Historic Landmark Commission
March 26, 2012
National Register Historic Districts
NRD-2012-0025
Old West Austin
1408 Wathen Avenue

Remove existing brick stoop and construct a new covered porch with second story balcony on a c. 1940 house.

2 FRONT ELEVATION
SCALE: 1/8" = 1'-0"

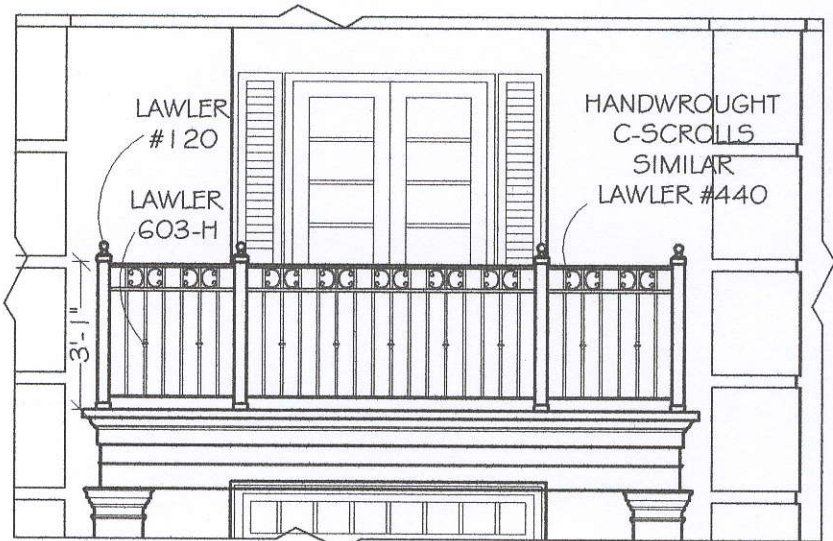
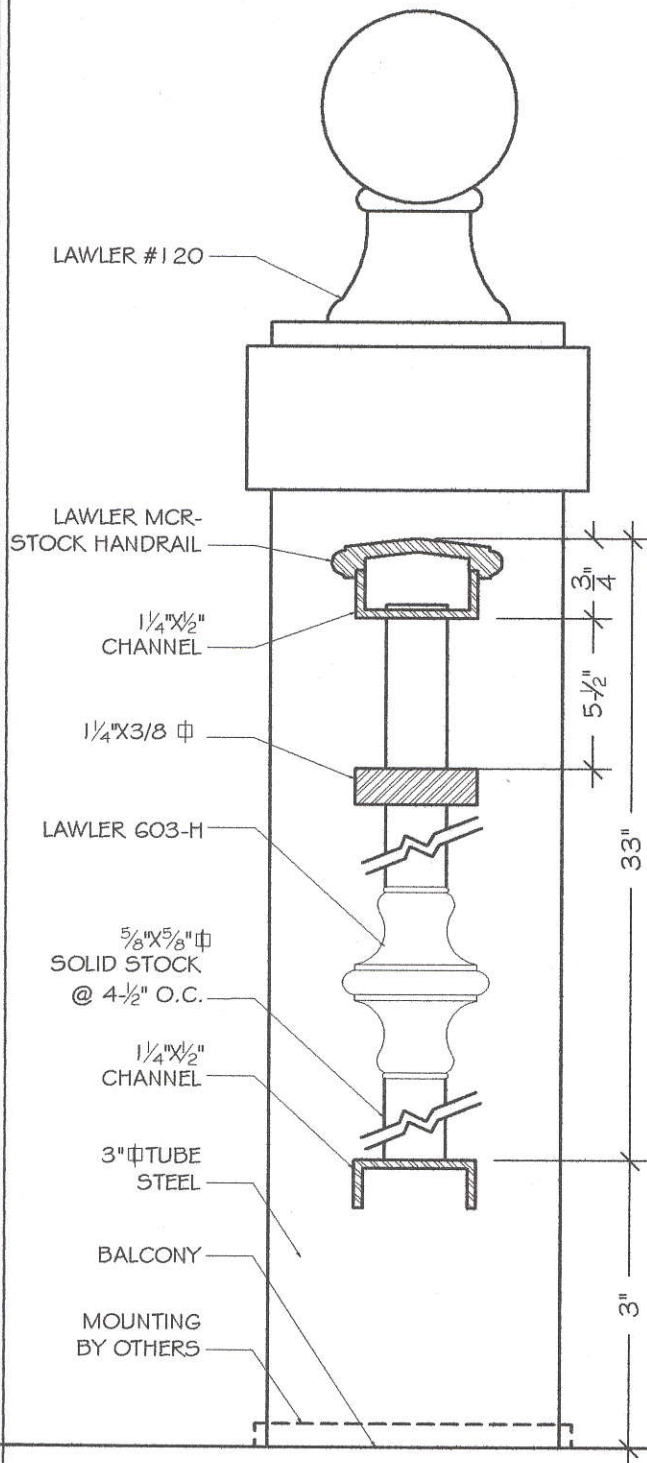
The applicant proposes to remove the existing balconette railing and brick stoop and construct a new second story balcony with decorative railing supported by unfluted, rounded columns and pilasters with Doric capitals.

Although the proposal adds new architectural details to the façade, they are of a scale and style that is compatible with the existing architecture of the house and do not have a significant adverse impact to the character of the house or the National Register District.

Staff recommends releasing the permit based on the proposed design.
